PRODUCT ADVISORY

Data Sheet Specification Update for Intersil Product ISL54103*

**Refer to:
PA11111**

Product affected: **ISL54103IHZ ISL54103IHZ-T7 ISL54103IHZ-T7A**

Old POD MO-193 – PA11111

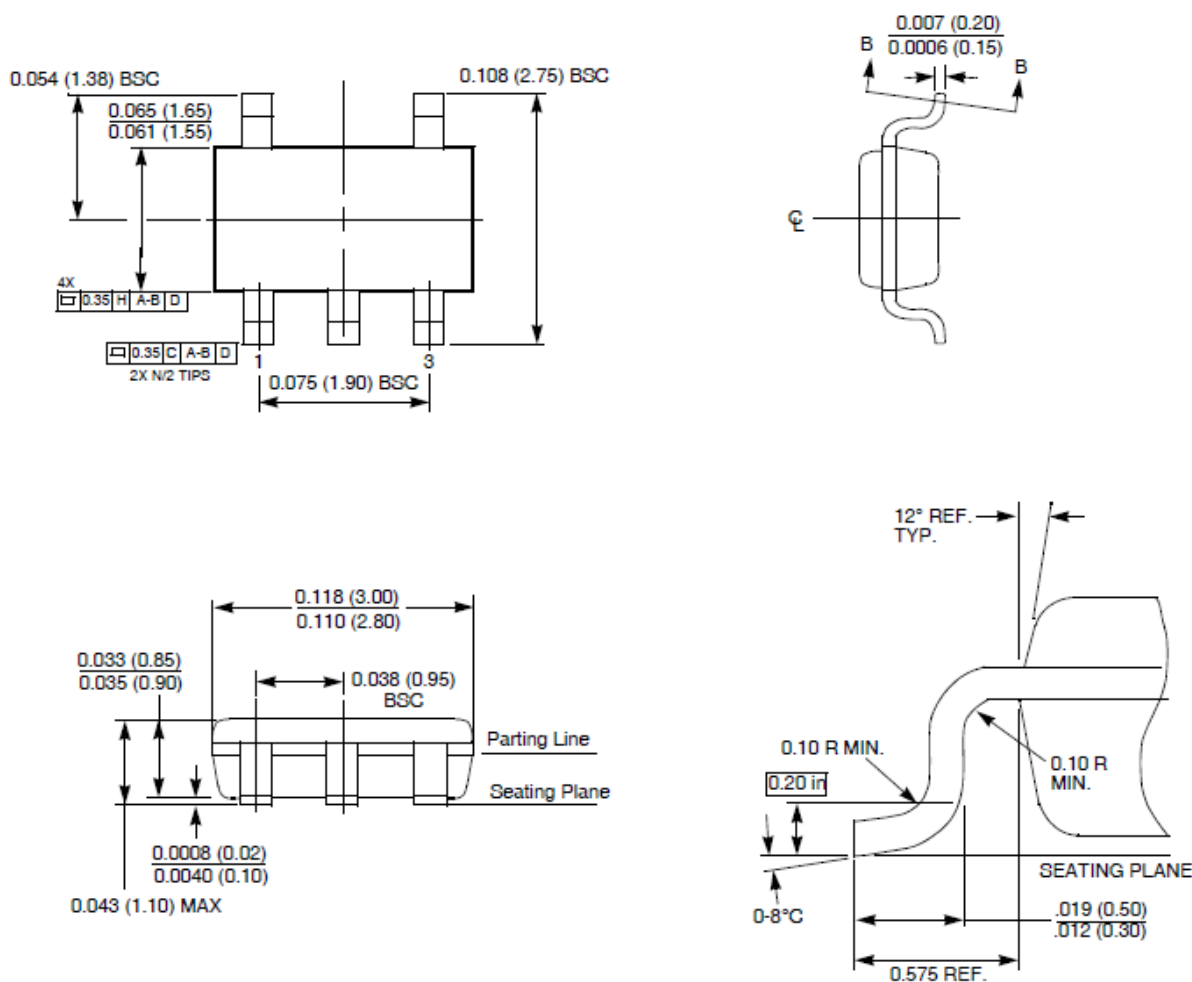
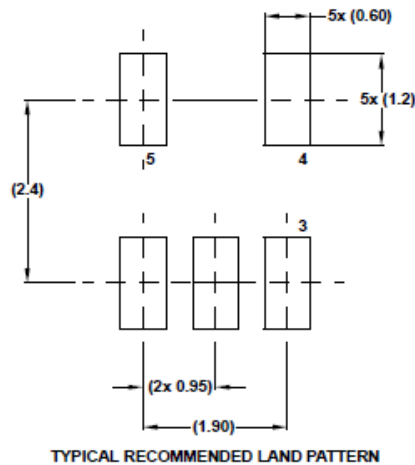
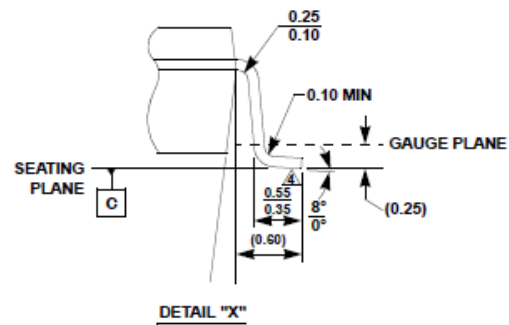
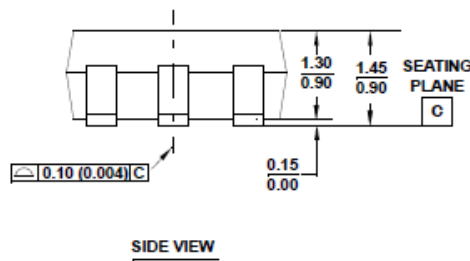
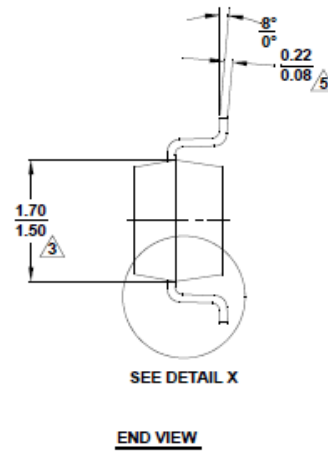
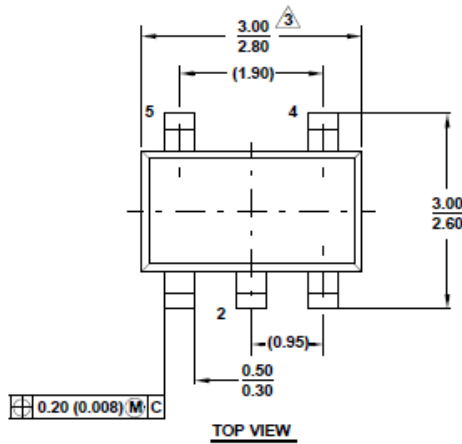
This advisory is to inform you that Intersil has updated the POD (Package Outline Drawing) referenced in the data sheet specification for the listed Intersil ISL54103* products. The POD has been changed to reflect JEDEC outline MO-178AA instead of JEDEC outline MO-193. The old and new PODs are contained on following pages. There have been no changes to the package or product itself. The updated data sheet is available on the Intersil web site at <http://www.intersil.com/data/fn/fn6303.pdf>.
